City of Ryde Submission

35 Waterloo Road, Macquarie Park – BTR

SSD-52947710

Council reference: COR2023/60
Submission Date: 30 November 2023

Figure 4: Site Plans showing the adjoining "7 Eleven." Site (Source Ryde Maps)
City of Ryde Council Submission SSD-52947710

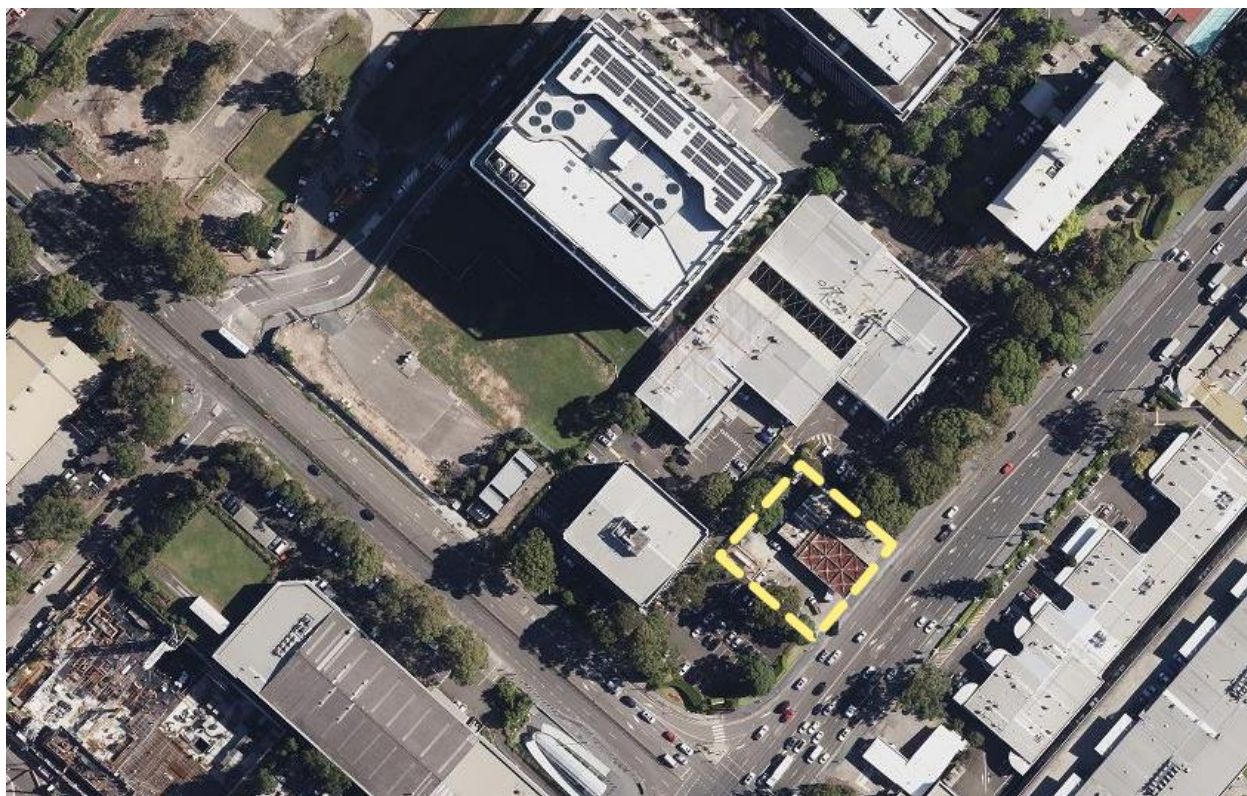
The Applicant has provided a copy of a letter which offers to purchase the 7 Eleven Site in 2017 (6 years ago). No details have been provided in terms of negotiation and the offer that was made.

In this regard, amalgamation of the 7 Eleven site with the site will achieve a better planning outcome, and the development would be consistent with applicable planning controls and the objects of the *Environmental Planning and Assessment Act, 1979* (EP&A Act). It is also acknowledged that agreement may not be reached for the sale of the adjoining property, however, it is reasonable to require information to determine whether adequate steps have been made to avoid site isolation. If this process is not followed, the issue has not been properly resolved and therefore any decision to approve the current application is premature.

In summary, the proposal would result in the isolation of the adjoining site to the 404 Lane Cover Road (7 Eleven Site) and in this regard the Applicant has not demonstrated that the correct process has been fully undertaken to satisfy the Courts Planning Principles to determine the planning merits of the proposal to develop the subject site alone.

Figure 6: Mark up of Macquarie Park Innovation Precinct Stage 1 Neighbourhoods – Design Guide (Base Source: Design Guide figure 26 – Page 67)

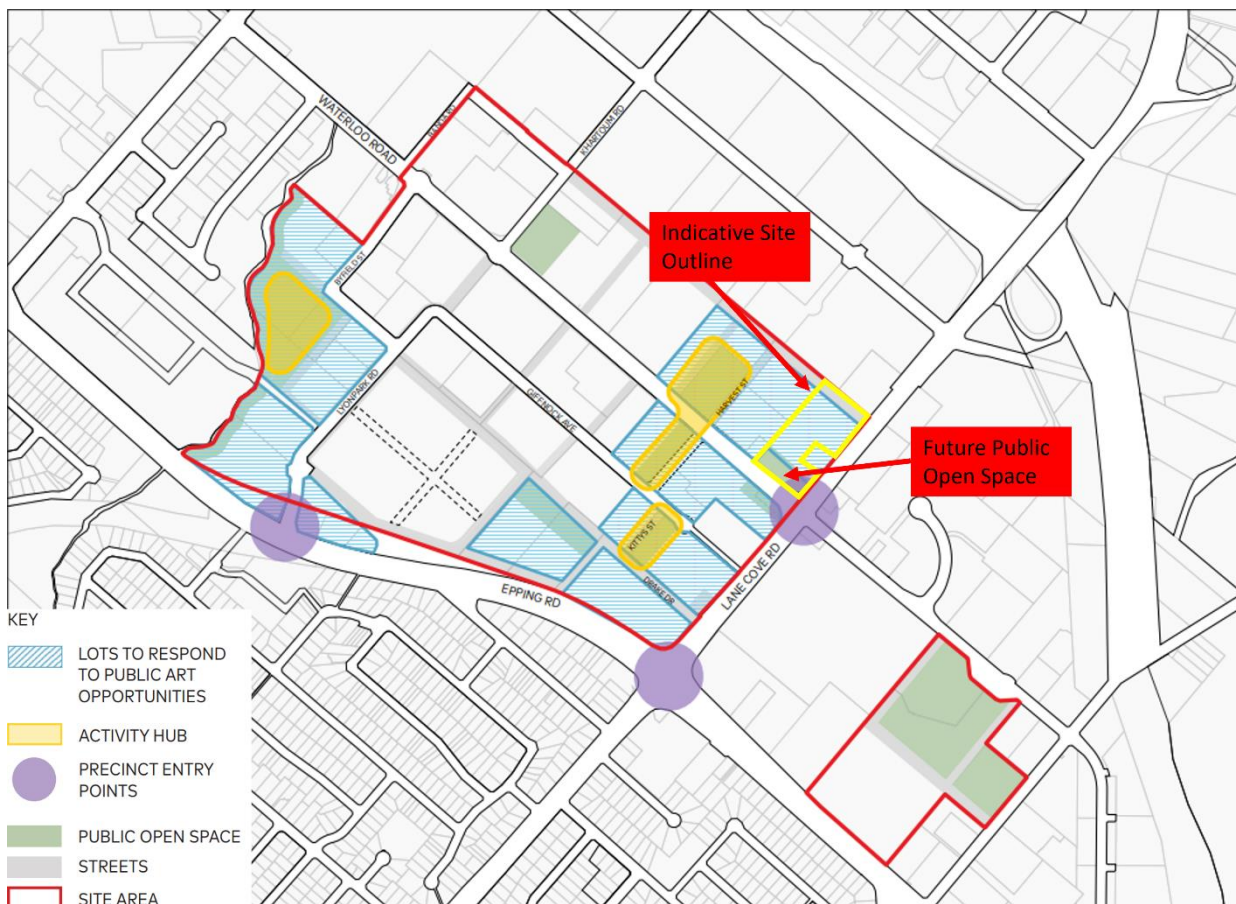
- The 1,793 square metres of open space identified in the design is generally of poor quality. It is of a size that barely meets Council’s minimum requirement for public open space, much of it forms setbacks from the buildings and will be significantly overshadowed. The landscape drawings provided indicate it is predominantly constructed of material that will make it feel like urban plaza area rather than a natural open space.

- Public Open Space in the location of the Development is not identified in the Macquarie Park Place Strategy and current exhibited Planning Proposal (Figure 6), therefore there is no strategic need for the proposed open space in its current location. The open space identified to be delivered as part of this application will only function to beautify the development and not provide any broader community purpose.

Figure 8: Figure 7 from Appendix 0 (Source: RWDI)

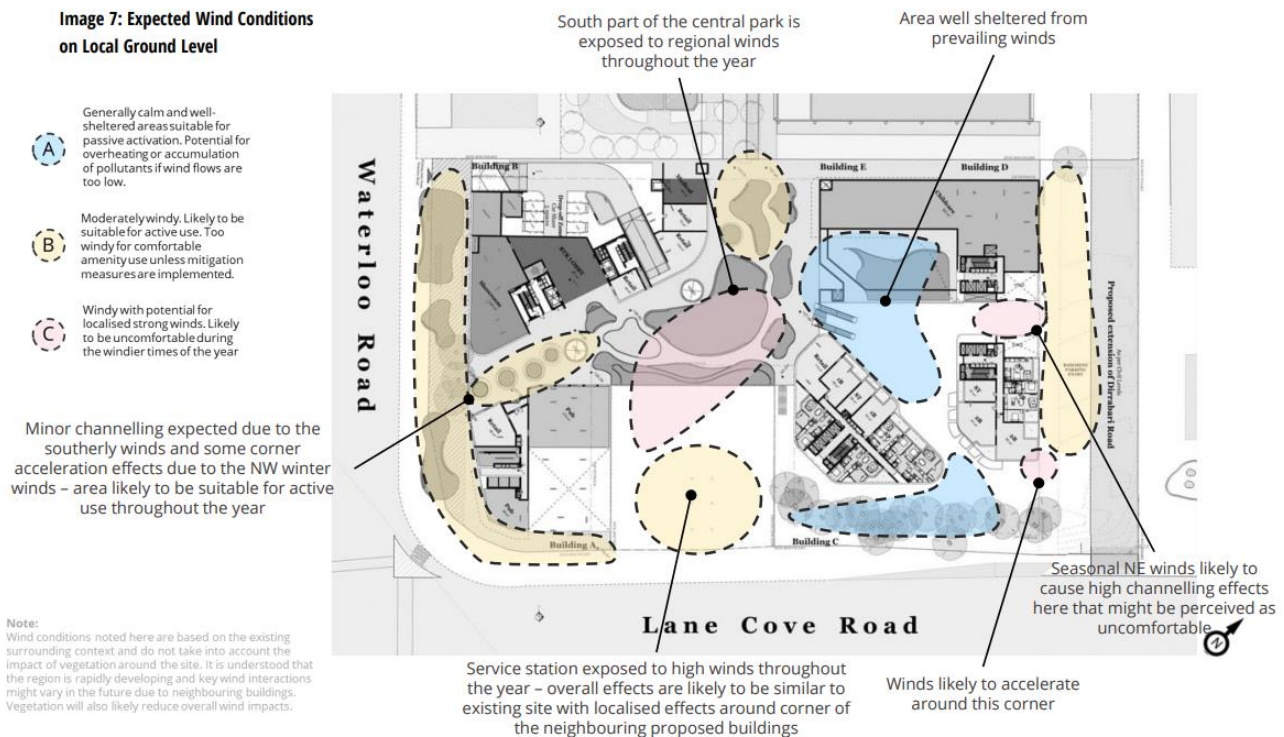
Appendix O - Pedestrian Wind Environment Assessment outlines that there will be significant wind impact throughout the entire development, with majority of areas being too windy for comfortable usage. This is particularly evident as the locations proposed for open space and site links are a high wind category (Figure 8).

These areas are likely to be used less frequently, and not serve its intended public benefit. Furthermore the area of high wind is the proposed active frontage, as such Council raises concerns

with the amenity and usability of this space given the associated wind impact. The wind impact in this location is not supported by Council and reconsideration of this area is needed to ensure the development can respond to appropriate wind considerations.

Council notes that plans for the apartments don't contain any wind shielding measures. It is unclear if the wind assessment has determine building specific recommendations for wind mitigation measures for each apartment building, as the following was stated in the wind assessment:

The architectural drawings submitted with the application have not drawn in the preliminary recommendations. Given the associated impact of reduced amenity on these dwellings, Council requests that the architectural drawings be revised to consider the design advise in Appendix 0 and any revised assessment.

Figure 10: Extract from the Public Domain Technical Manual

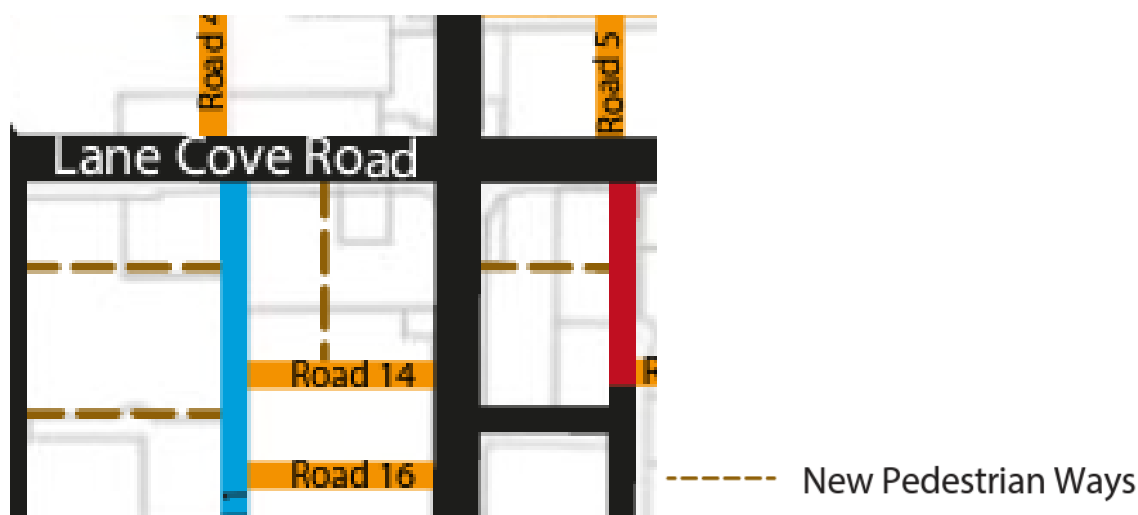
The plans do not detail a through pedestrian link as shown in the Technical Manual, a link is however shown extending diagonally through the site from the intersection of the Lane Cove Road and Waterloo Road. Possibly the reason for the link detailed in the technical manual not being provided is the presence of the petrol station, however the manual shows that the proposed link bypasses this property and should therefore be provided. As the Place Strategy notes the objective of a fine grain pedestrian network of pedestrian accessways it is considered appropriate that both the diagonal link and the link show required by the technical manual should be provided.
